APPEAL SUMMARY

Appeal ID: 27916	Project Address: 1947 NW Overton St
Hearing Date: 8/3/22	Appellant Name: Spencer Roedel
Case No.: B-003	Appellant Phone: 5022249560
Appeal Type: Building	Plans Examiner/Inspector: Joe Thornton, Wayne Close, Kurt Krueger
Project Type: commercial	Stories: 3 Occupancy: B, A-3, S-2 Construction Type: II-B
Building/Business Name: Whiskers	Fire Sprinklers: Yes - All levels
Appeal Involves: Erection of a new structure	LUR or Permit Application No.: 22-134880-CO
Plan Submitted Option: pdf [File 1] [File 2] [File 3]	Proposed use: Office/ Animal Hospital

FIRST FLOOR CODE PLAN
G1.12 1/8" = 1'-0"

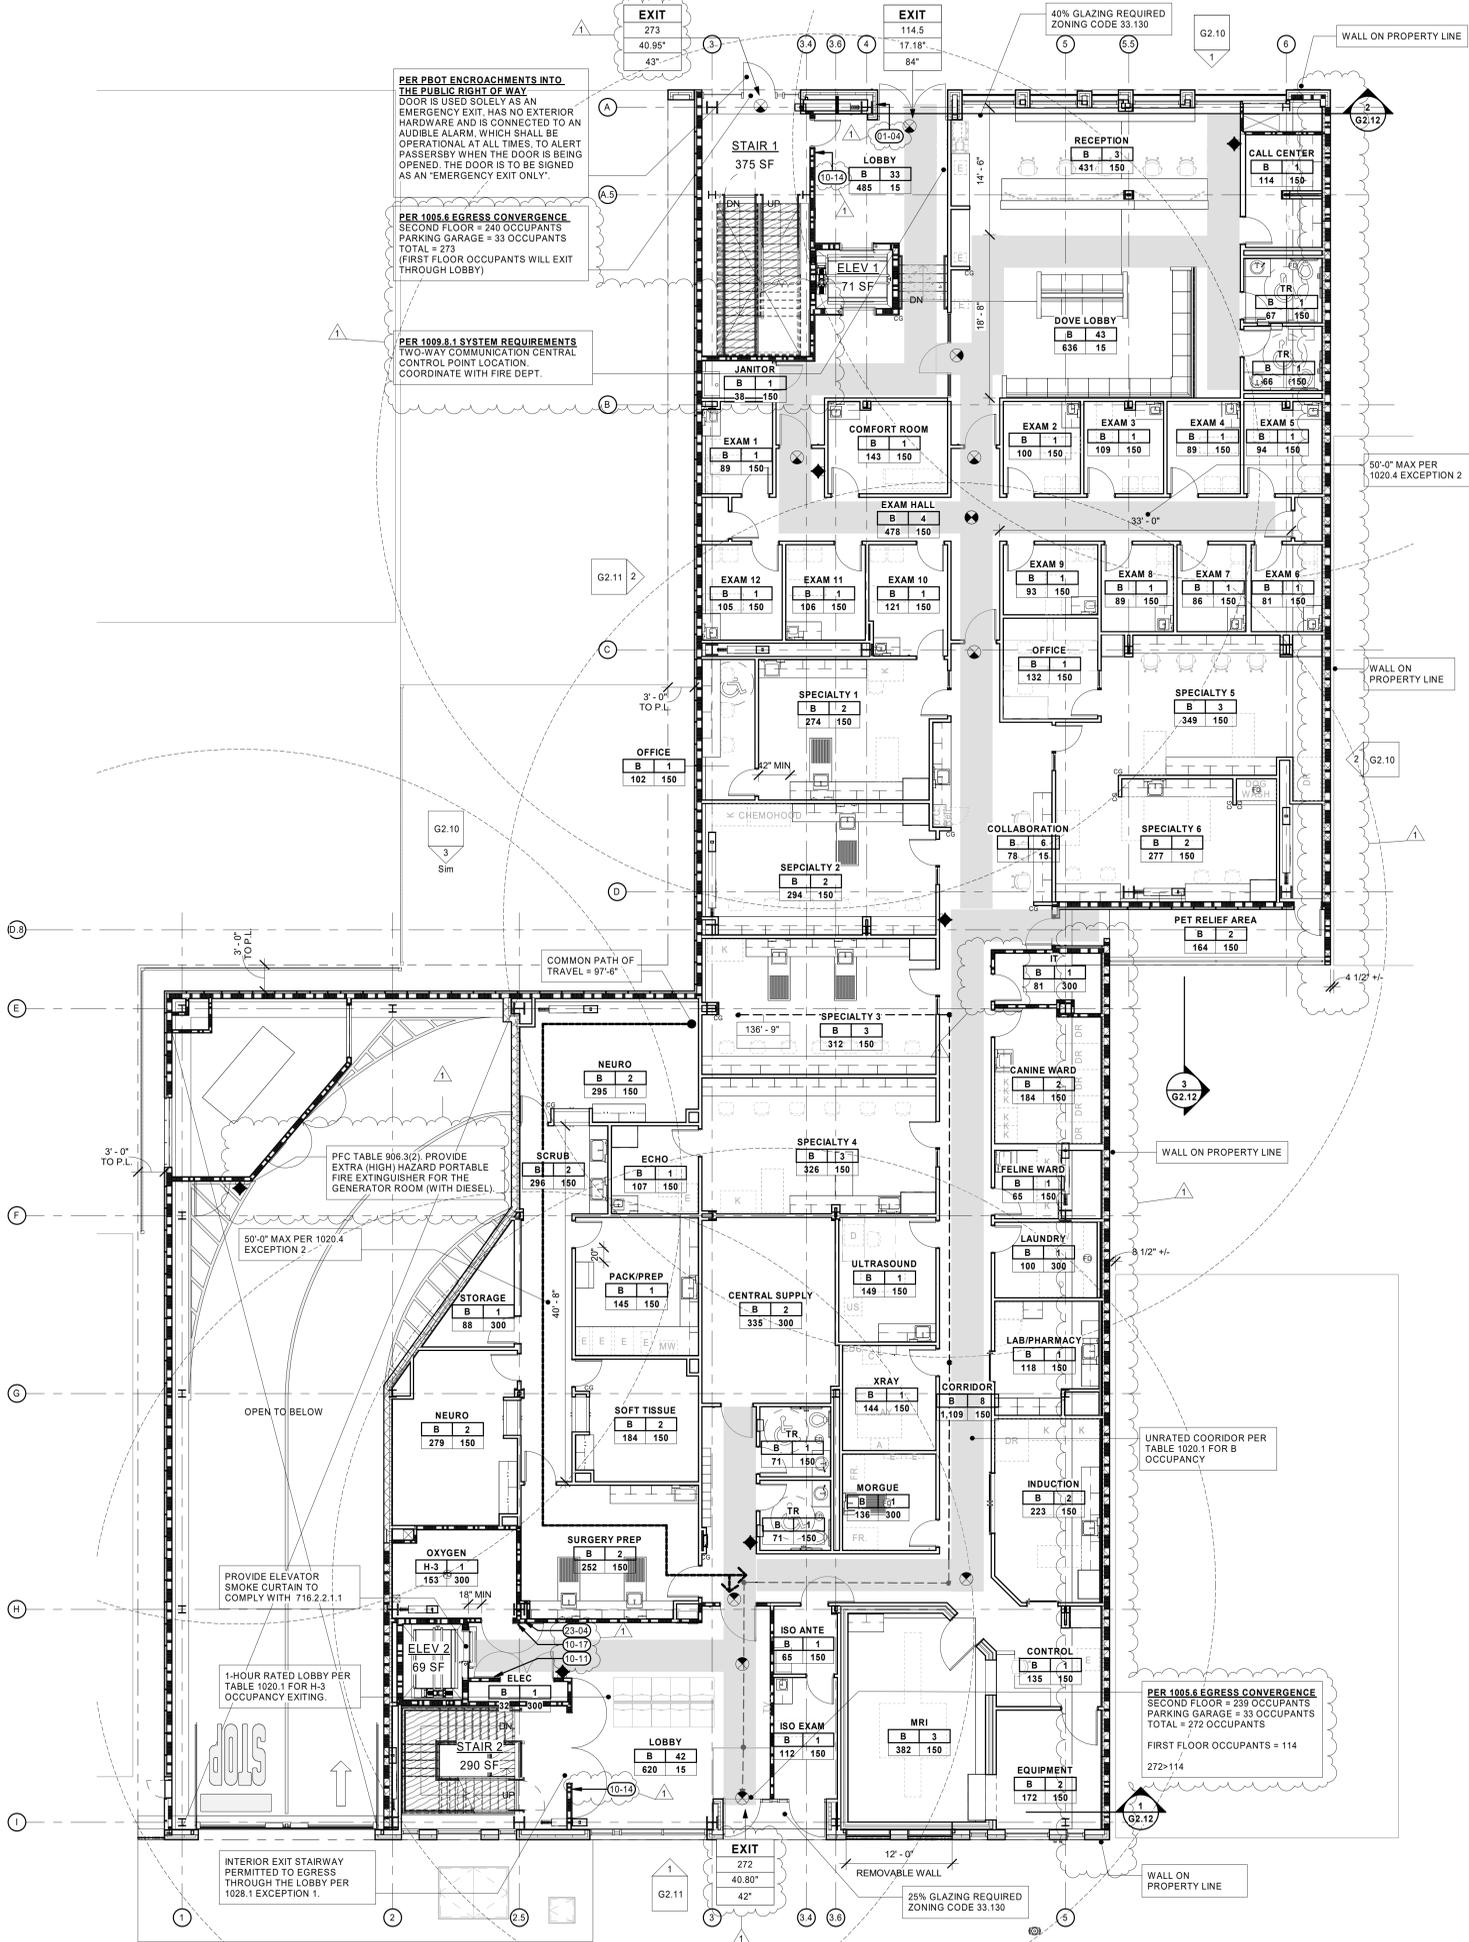
Code Modification or Alternate Requested i. Project restraints do not allow the Fire pump room to have a fire-resistant rated corridor to the enclosed exit stairs. Extra protections have been provided to meet the intent of the code.

- i. The proposed design is a 3-story mixed use medical center building over below grade parking level. The construction type is II-B. The building is fully sprinklered per NFPA 13. The fire pump room is proposed to be a 2-hour rating which exceeds the 1-hour required rating. Access to the fire pump room will be via two direct paths of travel 1) access directly along the parking garage drive aisle from the public way through the underground parking garage; and 2) access through 2-hour rated stair enclosure and then along the parking garage drive aisle. Per OSSC 722.2.1.1, the calculated fire resistance of the parking garage 24" cast-in-place walls and 12" slab between the parking garage and first floor is greater than 4 hours which exceeds the pump room rating.

- ii. The unpartitioned, fully sprinkled and highly fire resistive parking garage allows a large number of potential routes to access to the fire pump room; access from rated stairs and along the parking garage drive aisle. The fire pump room is 70' from exit stair #2, 138' from exit stair #1, and 45'

from the termination of the parking ramp. This layout gives first responders multiple paths to access the fire pump room, as opposed to a single access path.

1. Omission of 2 hour fire rated passageway connecting fire pump room to exit: Granted provided the portion of the building containing the fire pump is protected by a sprinkler system that does not rely on the fire pump.

1 FLOOR PLAN - FIRST FLOOR - SOUTH - HVAC
3/16" = 1'-0"

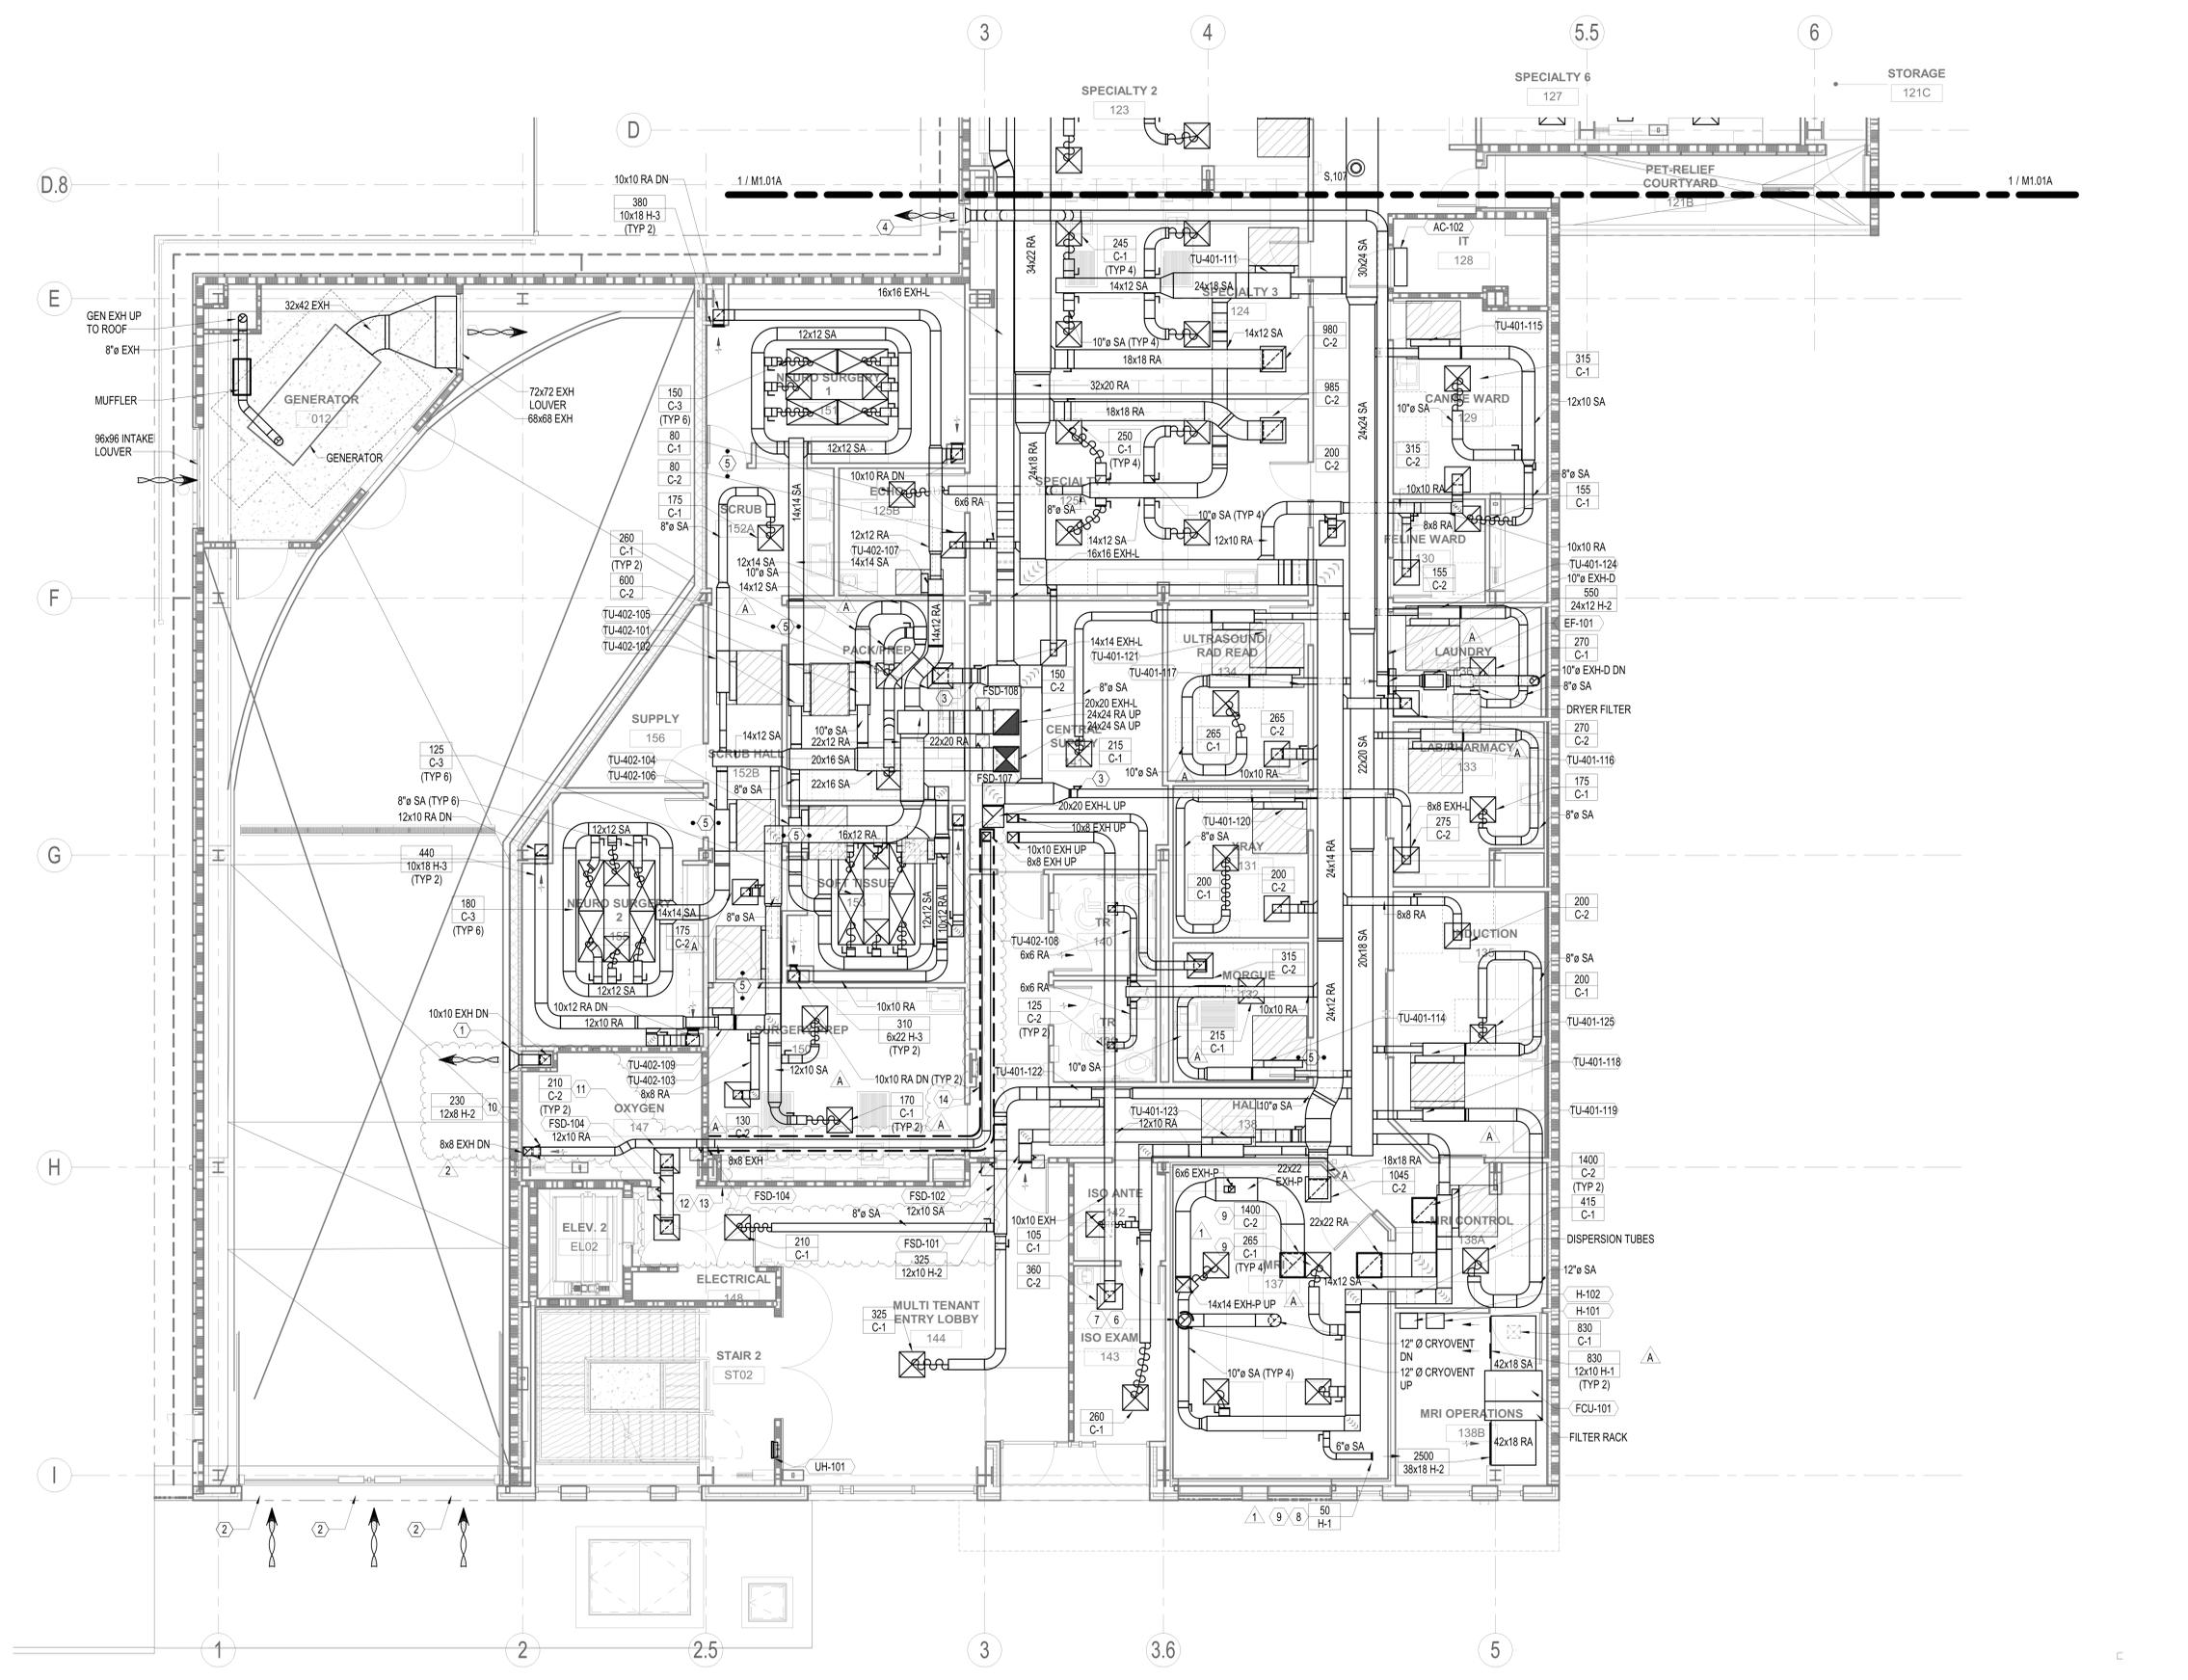
- i. Omission of FSD in louver penetration of (2) hour fire barrier enclosing Generator Room
- ii. Generator radiator exhaust to be discharged through actively ventilated parking garage.

- i. The generator radiator exhaust will be discharged through the parking garage through a louver. The louver will be protected by sprinklers on both sides per NFPA 13, with sprinklers provided between 6" and 12" from both sides of the opening. The open area of the generator louver is 72" x72".
- ii. Wall mounted signage will be provided at the exhaust louver stating "Do Not Block Louver.

Generator Air Exhaust." The louver is located above the access ramp and will be clear of garage use. The remainder of the generator room will be protected by the required (2) hour rating.

3a. Sprinkler protection in lieu of fire damper at radiator exhaust opening for emergency generator located in 2 hour enclosure: Granted provided sprinklers are spaced not more than 6 feet apart and placed a minimum of 6 inches and a maximum of 12 inches from the opening and a maximum of 12 inches below the ceiling. Sprinklers are to be installed on both sides of the opening. A separate permit from the Fire Marshal's Office is required.

3b. Generator discharge into parking garage: Granted provided minimum ventilation rate per OMSC 404.2 is confirmed at time of mechanical permit plan review and provided signage is posted at exhaust louver "Do Not Block Louver. Generator Air Exhaust"
